**RESPONSE TO COMMENTS FROM MR. BUSH Y. ABADIR (MR. ABADIR)
FOR THE PROPOSED CLOSURE OF CHEVRON SERVICE STATION #9-3969 (SITE)**

Case No: 2916
Site Address: 650 E.Laurel Drive, Salinas, California.

SOIL CONCENTRATION MAP
Chevron Service Station No. 9-3969
650 East Laurel Drive
Salinas, California

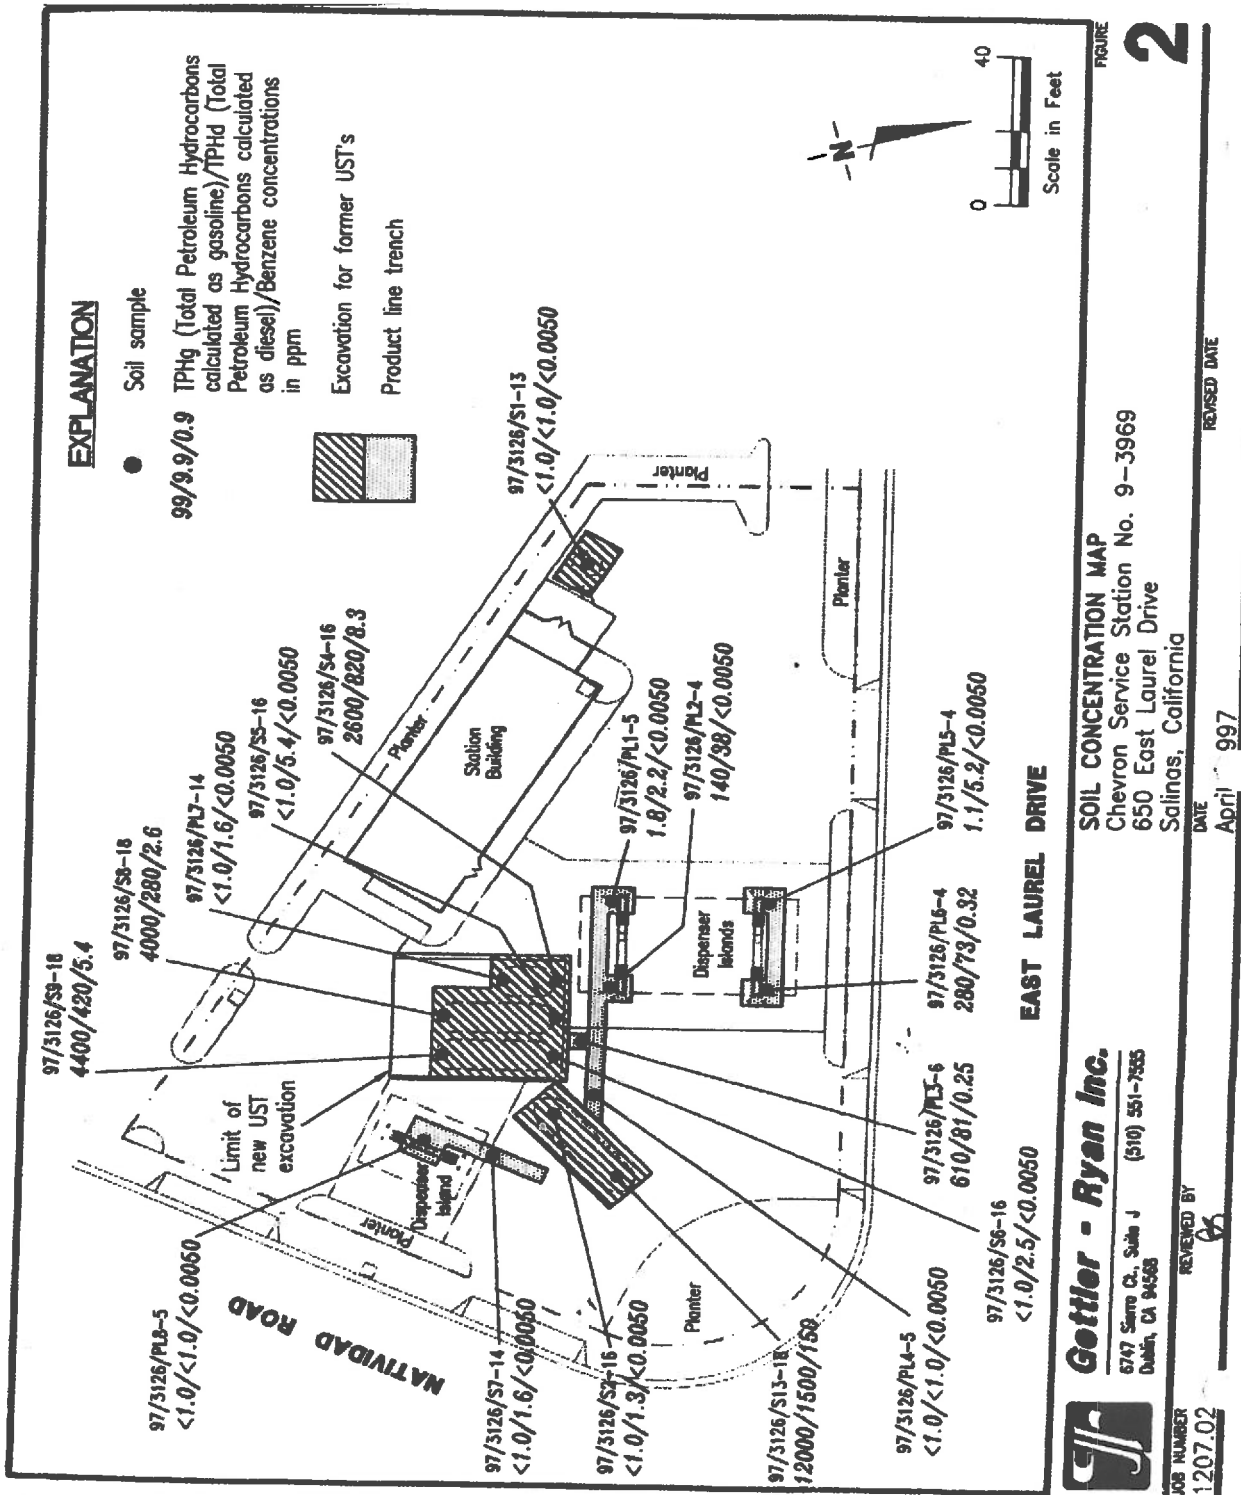
2. Mr. Abadir questions whether cumulative soil and groundwater data provides an assessment of potential and reported unauthorized releases for all UST systems operated at the Site between 1972 and 1977.

The Geotracker record does not contain a UST removal report for USTs removed during 1977. However, the record indicates that the general site configuration (location of build, pump islands, parking areas, and driveways) did not change significantly between 1972 and 2005. The oldest UST removal data in Geotracker was collected during the 1997 tank removals. It is highly likely that soil samples collected in 1997 provide the best available record of soil conditions prior to 1997. See Attachment I for a summary of soil analytical data and sample locations from the 1997 tank removals.
